P840-96-S047
February 16, 1996

Subject: Registry of Radioactive Sealed Source and Devices
F/A-18 Laser Target Designator/Ranger

References: (a) Registry No. NR-313-D-102-S, dated June 6, 1991
(b) Aeronutronic letter M110-RPM-95-271, dated June 14, 1995
(c) Telecon between NRC and Aeronutronic on October 31, 1995

P288255

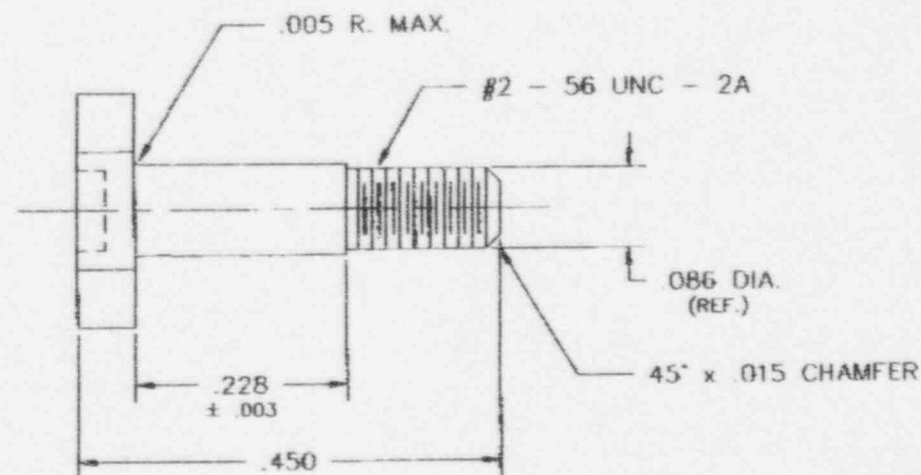
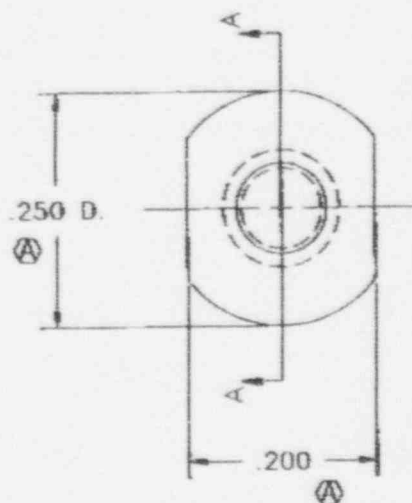
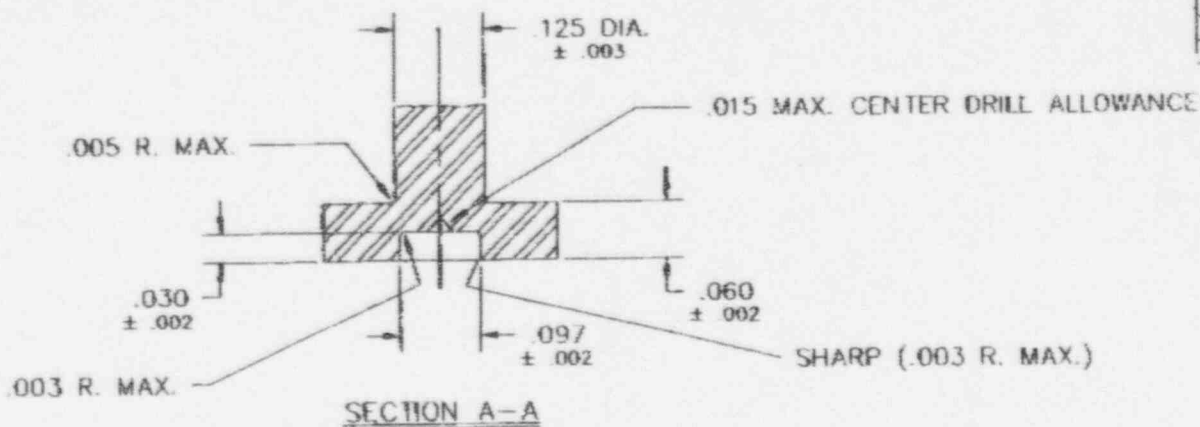
Provide detailed drawings of the Source Holder and specifications for the adhesive used in its assembly.

Provide assurance that the female thread in the Access Cover matches the male thread on the Sealed Source. How is the Source held in place?

Amersham's detail drawing of the Source Holder (Amersham's Drawing No. P288255) is provided herewith as Attachment 1.

The Optical Access Cover (P/N 66910106-9) drawing specifies that the cover will be drilled and tapped for a .086-56 UNC-2B Helical Coil Insert (see Attachment 4). This thread size matches the .086" diameter #2 - 56 UNC-2A threads on the source holder as noted on Amersham's detail drawing (see Attachment 1) and Sheet 9 of the SCD (see Attachment 2). The "B" in the Optical Access Cover drawing thread specification denotes a "female" thread. The "A" in the Source Holder drawing and SCD thread specifications denotes a "male" thread.
